TOWN OF KILL DEVIL HILLS

Subject: **SITE PLAN REVIEW— 207 W. Martin Street — Proposed Cluster Home Development in the Low Density Residential Zone — Including 10 “3-bedroom” and 11 “2-Bedroom” Long-Term Residential Units**

Subject: **SITE PLAN TECHNICAL REVIEW 2 - 207 W Martin Street in the Residential Low Zone
Proposed Cluster Home Development**

Cover and Index Sheet
 For:
Village West
 Location:
207 West Martin Street
 Parcel in Kill Devil Hills
 Kill Devil Hills Dare County North Carolina

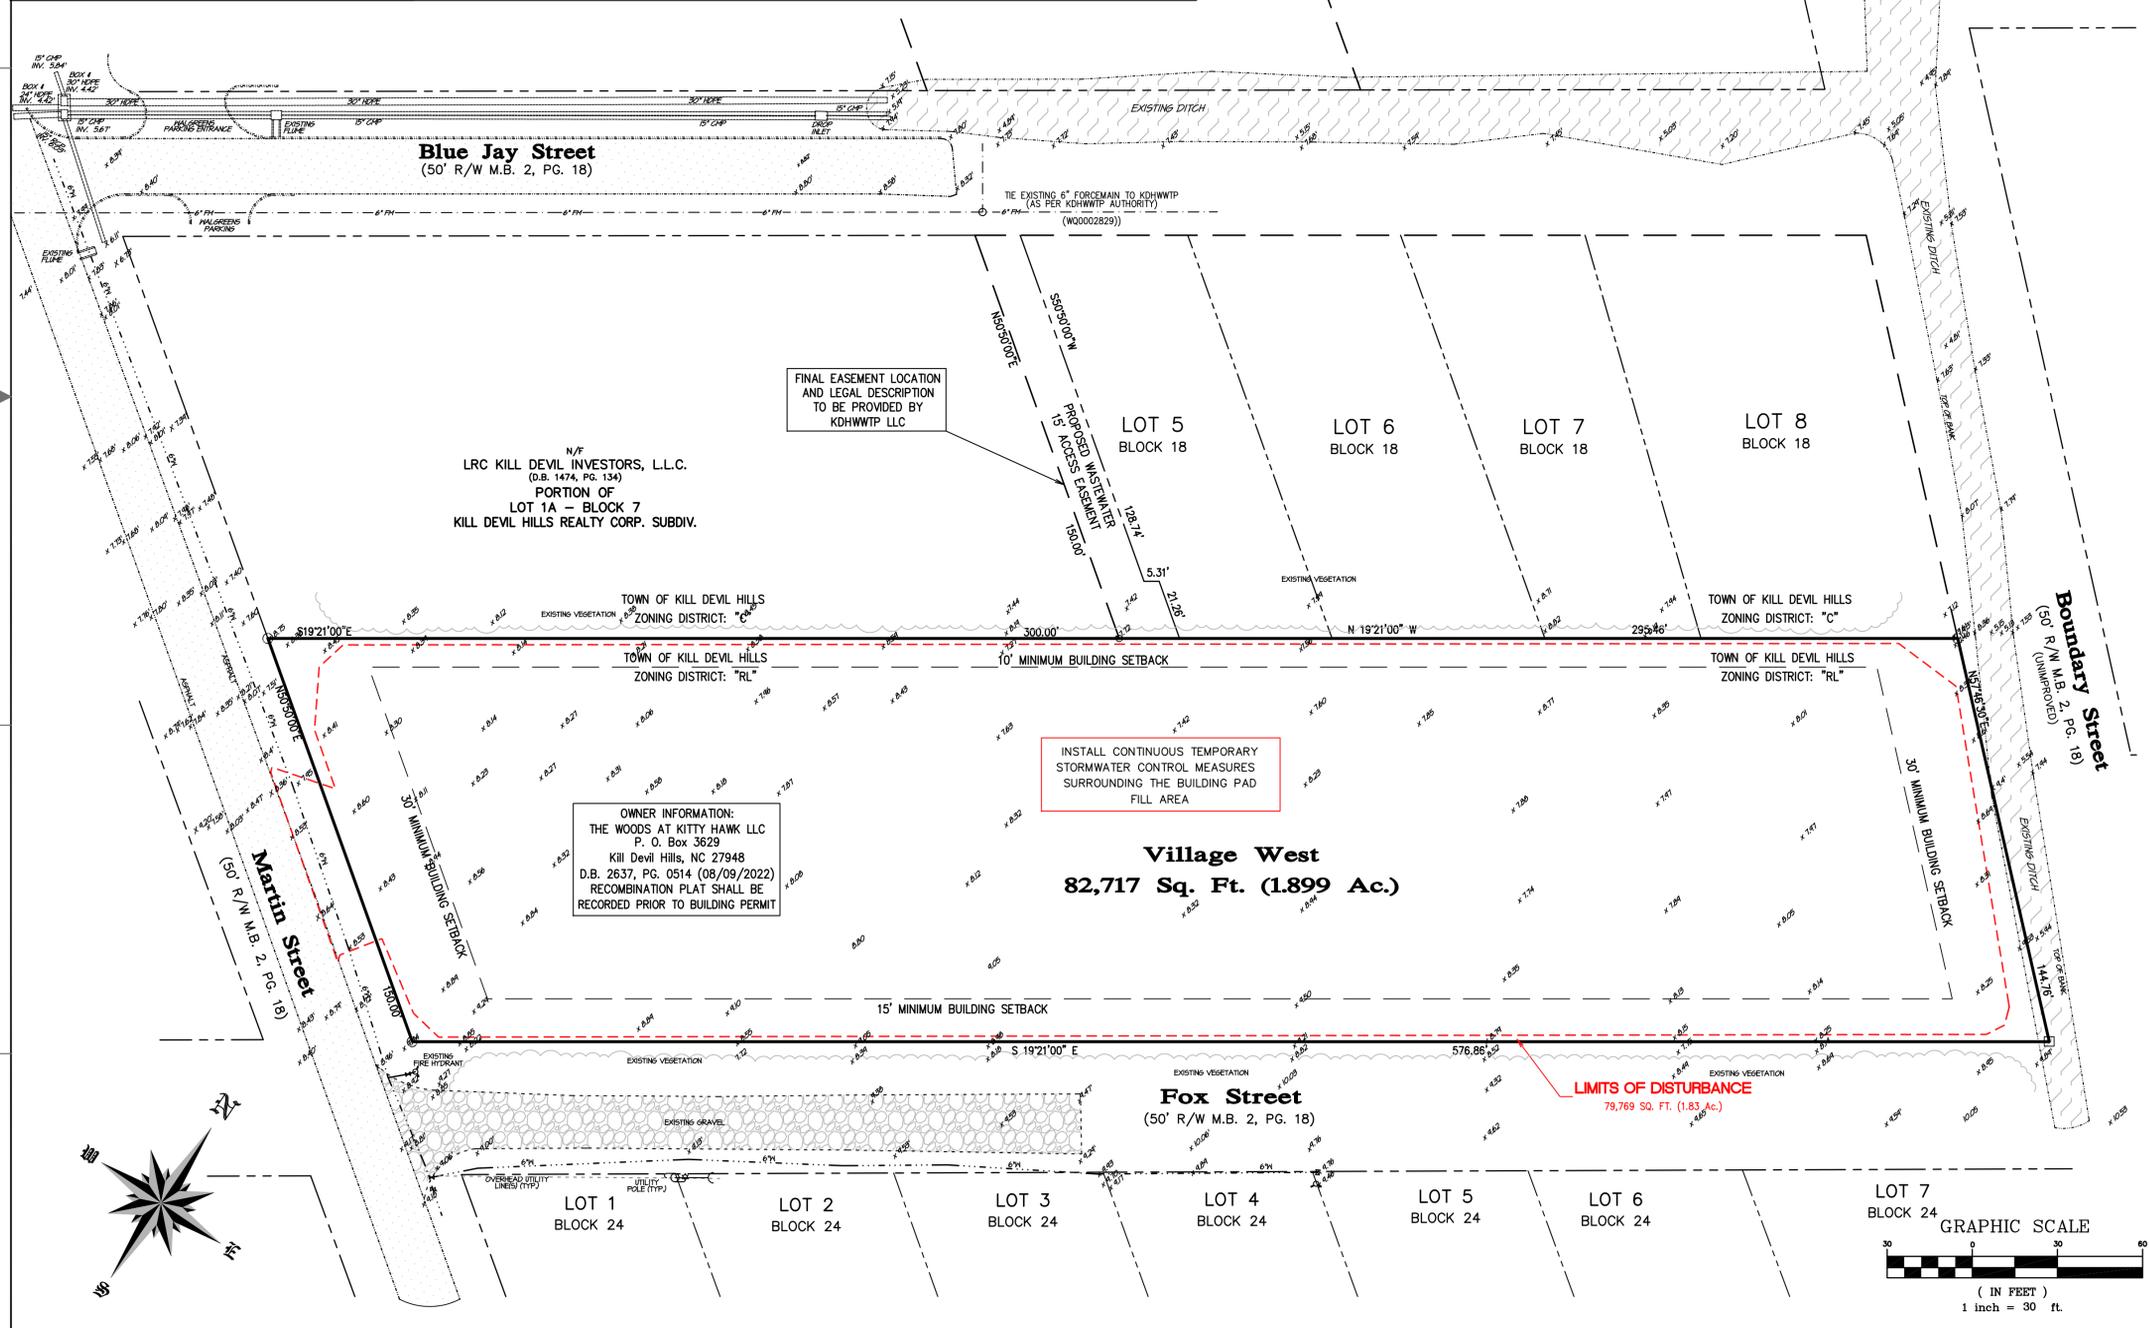
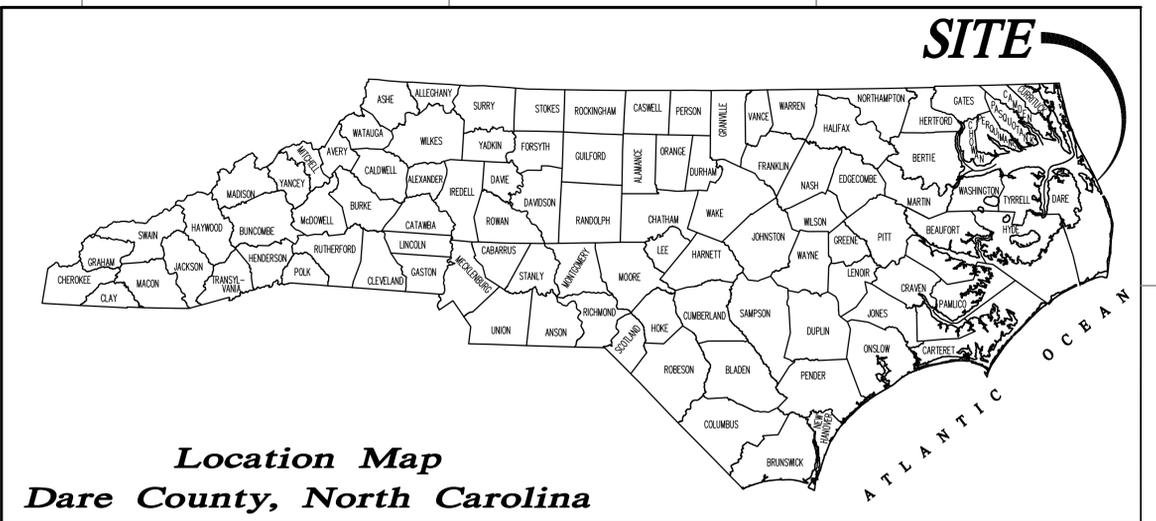
1. Provide willingness to serve from KDHWTP, LLC. **Eddie to provide**
2. Sheet Index shows sheets C6 & C7, they are not included in plan set, please advise. **Print plus error will provide full sets** ✓

Add in General Notes on all sheets:

- a. Zoning: Low Density Residential: Special use "Cluster Home" For long-term occupancy. Remove short term occupancy. **Revised** ✓
- b. Recombination Plat or Legal Agreement shall be recorded prior to building permit issuance. **Surveyor to prepare.**
- c. All building shall be long term occupancy per 153.002. Include Definition "Long-Term Occupancy. A residential dwelling that is occupied and used for residency and housekeeping purposes for a period of 31 days or more and has a use agreement recorded with the Register of Deeds that requires 21 or more consecutive days' minimum occupancy by single tenant(s) in perpetuity." **Note Added** ✓
- d. Long-Term use agreement shall be recorded with Dare County Register of Deeds prior to issuance of a building permit. **Note Added** ✓
- e. Revise "NAVO 88". ✓
- f. Density: 12 units per acre. Note "Max Allowed" and "Proposed". **Note added** ✓

Site and Utility Plan
For: **Village West**
Location: **207 West Martin Street**
Parcel in Kill Devil Hills

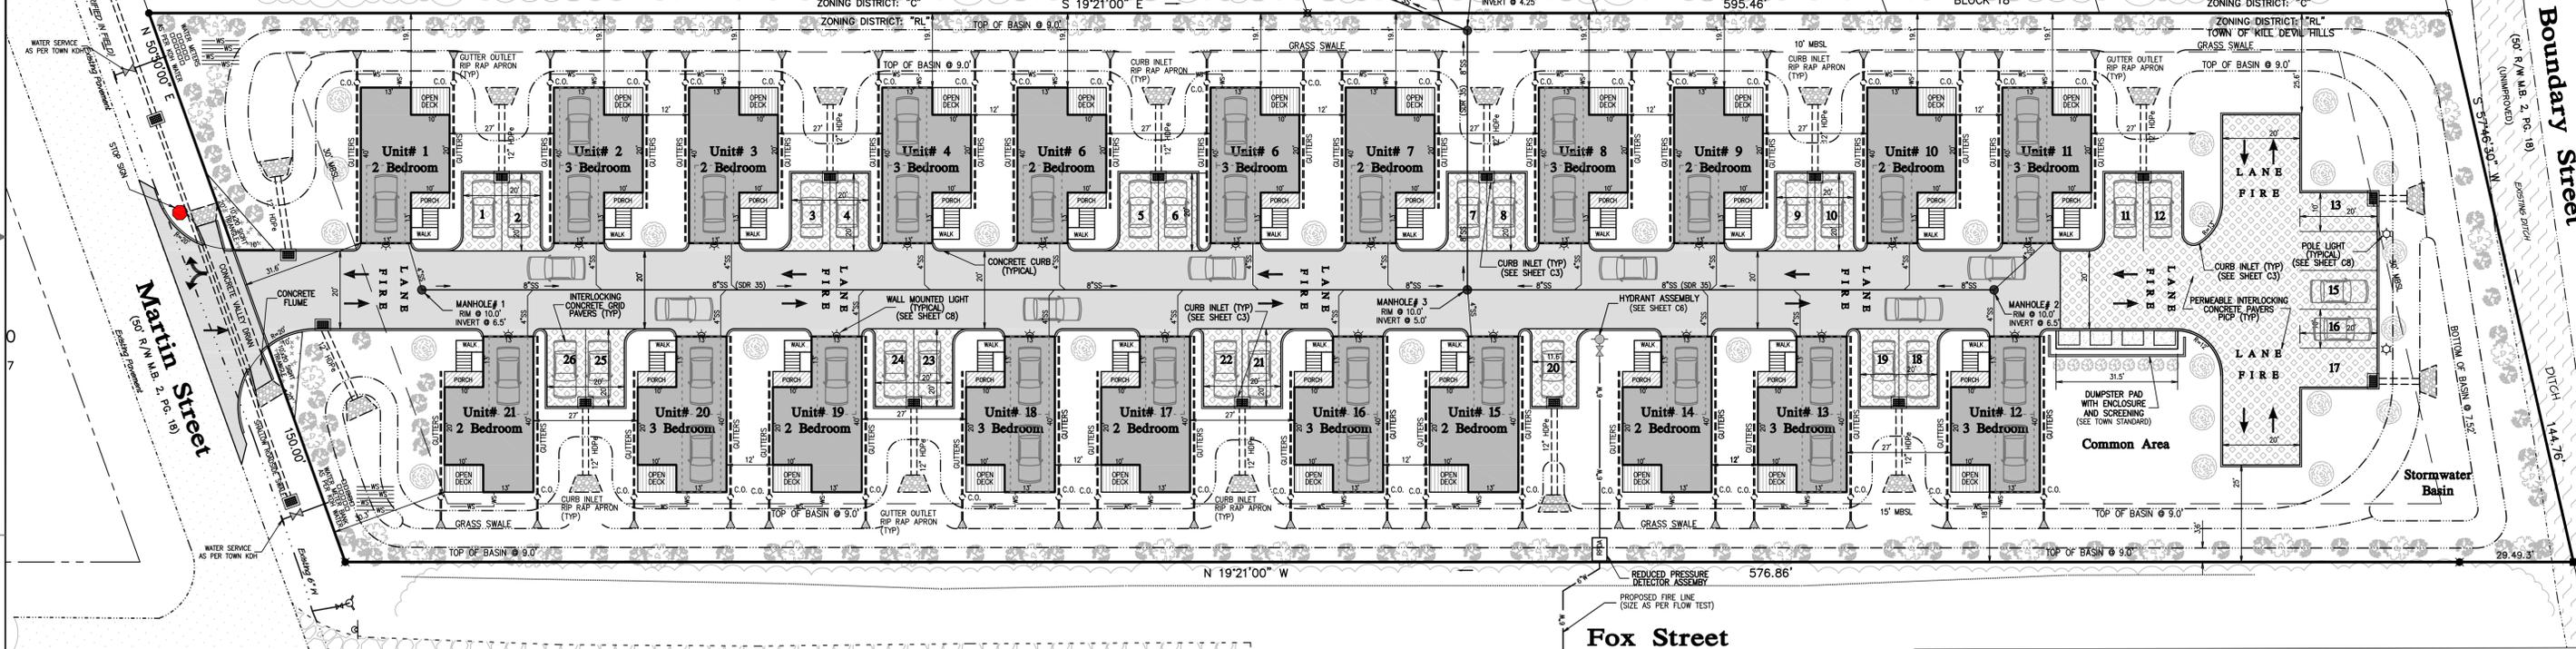
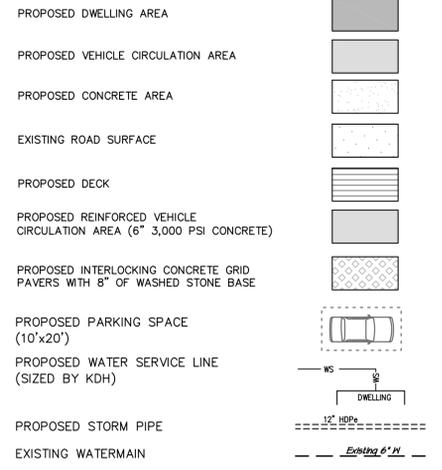
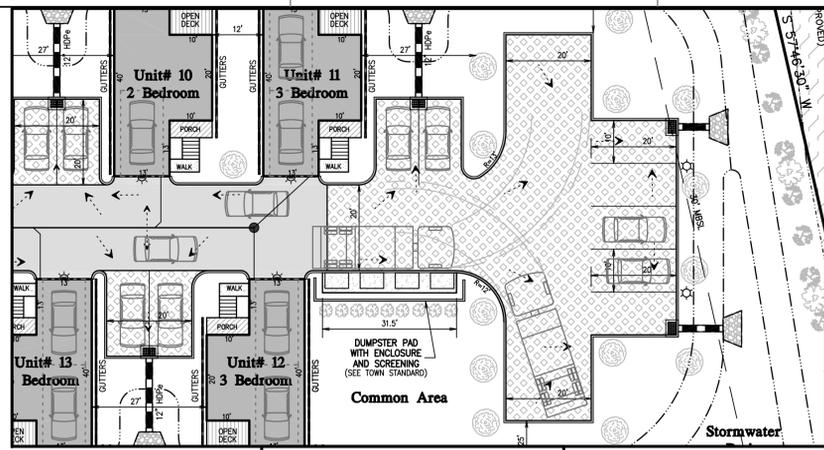
Sheet C2:

- a. Confirm sight triangles are 10'x20'. **Added Dimensions** ✓
- b. Proposed HVAC stands and units are not shown on site and included in lot coverage calculations, confirm proposed locations. **Added to Building plans ground floor (ground level under back deck.)** ✓
- c. Add "15' MBSL" to setback along Fox Street. **Added** ✓

6. Show truck turn around template for fire/garbage truck in the hammerhead at the south end of the site. **Added at top of sheet C2**
7. Stormwater drop inlet details depict a 24"x24" box and grate. Drop inlets in the right-of way need to be a 24"x36" box and grate. Grate and frame shall be ductile iron Capitol Foundry item: CB-2436*SH-PED or approved equal. **Revised Box and added Grate**

SIZE	PROJECT NUMBER	REV	SHEET NO.
D	226733	-	C6 OF 8

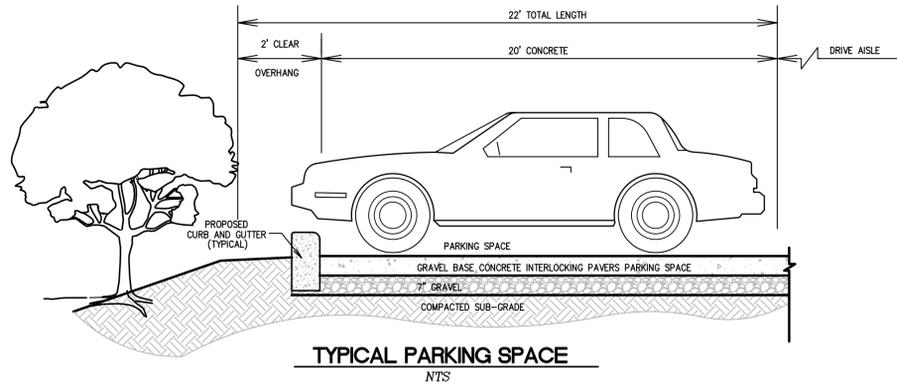
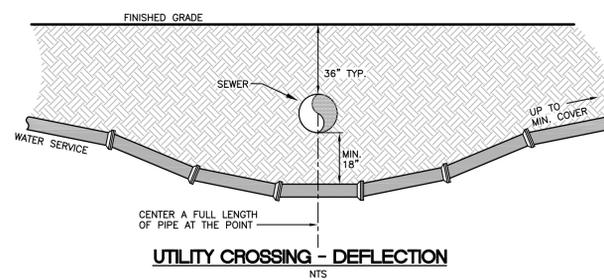
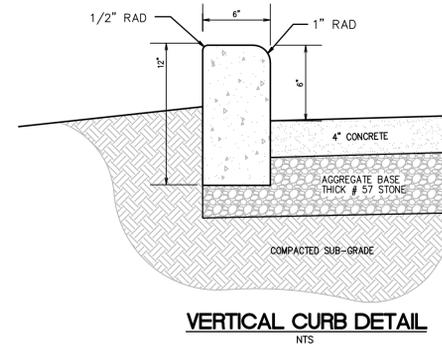
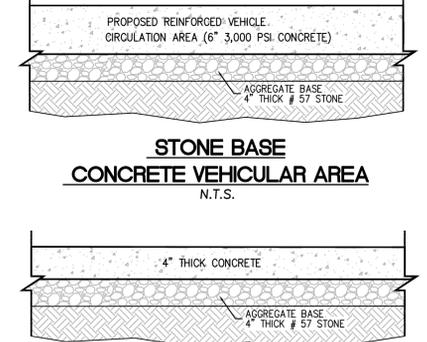
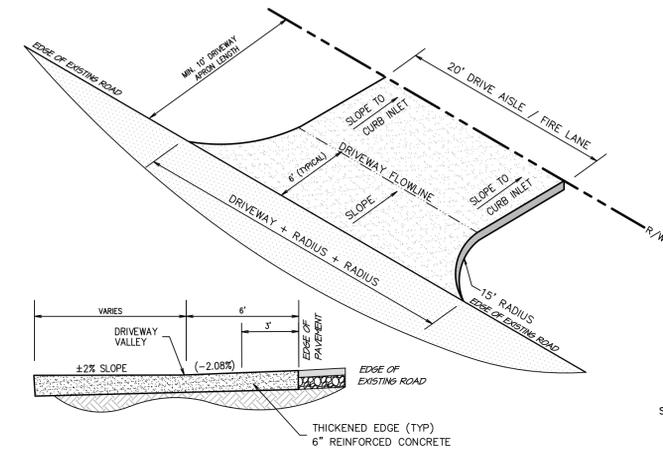
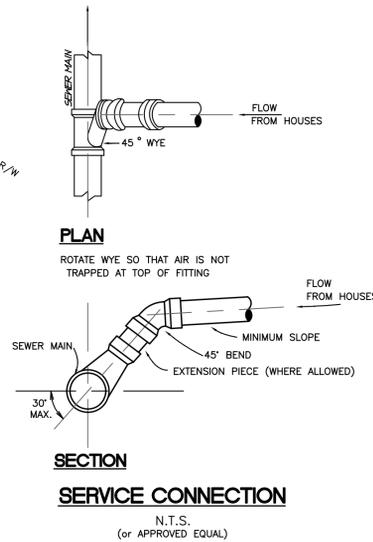
5. KDH Wastewater Encroachment Agreement will be required for any wastewater infrastructure constructed in Town right-of-ways. **Note Added**
6. The Town of the Kill Devil Hills Standard Wastewater Notes for work within the Town Rights-of-Ways shall be included on the plans for any work in the Town-Right-of-Way. Standard are provided in the following section: **Notes added C6**

- Seeding and Stabilization - seeding to be in place within 5 days of project final installations. Grass growth within 10 days. Special note - as it appears the project may be conducted during the hot/dry summer months, it will be of the utmost importance for the contractor to water the new seeding at least once a day, if not more, in order to get growth and stabilization. **Added notes on C6**

- d. KDH's driveway standard is 6" thick for the 3' adjacent to the existing road; add a 3' dimension to the entrance detail on C6. Perhaps it would be more appropriate to increase the thickness of the entire entrance to 6" or 7", side the on-site concrete drive is 6" reinforced concrete. **Revised all sheets.**

1. Water test shall be done to determine water flow for fire suppression. **Note added**
2. Once the new Hydrant is installed this will need to be tested to see how much water is available from this dead end hydrant. **Note added**
3. The fire department uses NST (National Standard Thread) **Note added on Detail Sheet C6**

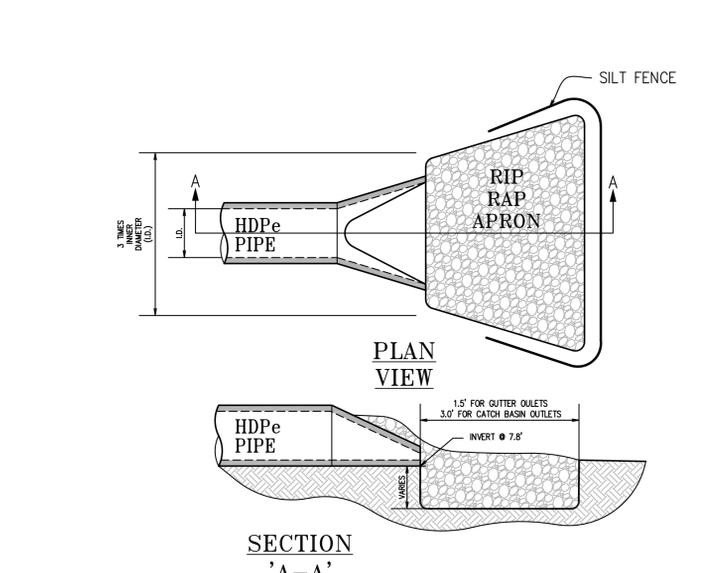
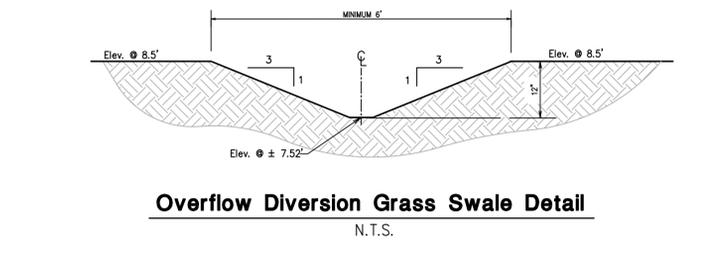
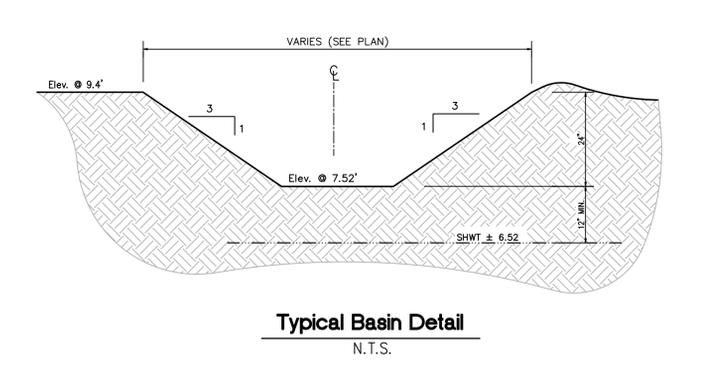
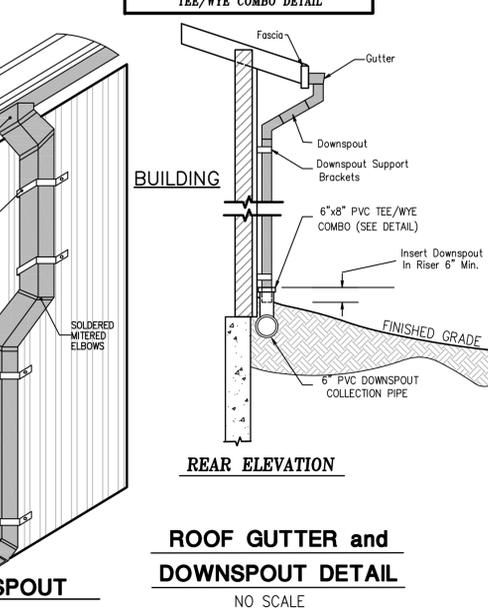
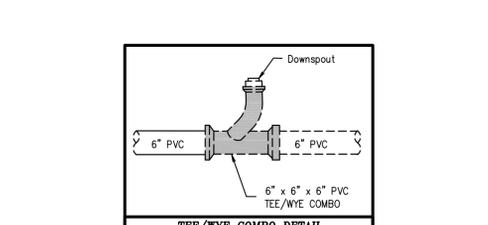
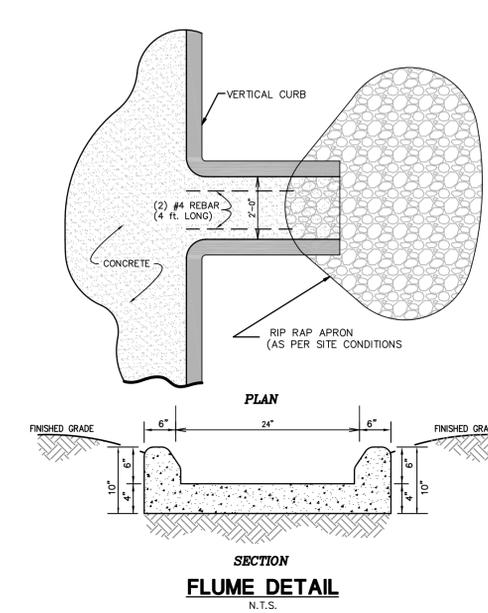
2. We consider it a necessary practice to make sure that the "top of bank" of stormwater management swales and basins have a proper relationship to the elevation of adjacent properties. It appears this may not be the case along the eastern boundary, For example, near the "lift station" site, a proposed 9 contour is shown about 1' inside the eastern boundary, with an existing ground grade of 7.58, 17" lower. **Basin cross section added on C7 at this point**

- a. Show more clearly, using Section A-A or a grading tie-line, or both, where and how the top of bank grade ties down to existing. We consider a 3:1 slope or gentler appropriate, unless some sort of wall treatment is used. **C7**

3. Minor items:
- a. Make sure the BMP typical sections on Sheets C7 and CS2 match each other and reflect the comments in 2 above. The section on CS2 has an incorrect top of storage elevation shown. **revised**

SIZE	PROJECT NUMBER	REV	SHEET NO.
D	226733	-	C8 of 8

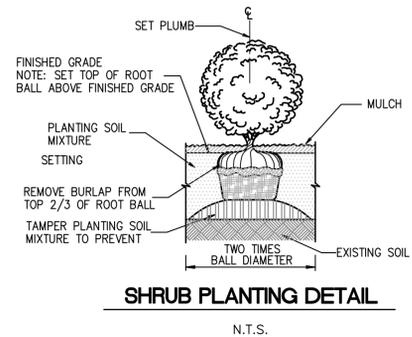
1. Provide willingness to serve from KDHWTP, LLC for wastewater.
2. General Notes: Revise Typo “Long Term Occupancy” Revise 21 to 31.
3. Include Note: Lots to be combined by recombination plat.
4. Revise Sheet C8 Light Pole Detail Mounting Height

SIZE	PROJECT NUMBER	REV	SHEET NO.
D	226733	-	SC1 OF 2

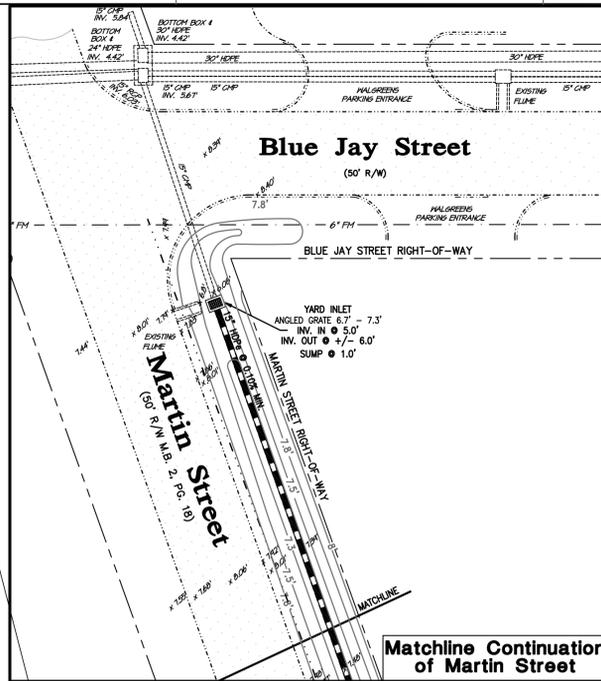
Sheet SC1:

- a. Add to notes: "State Stormwater Permit Shall be required prior to permitting." **Added note** ✓
-
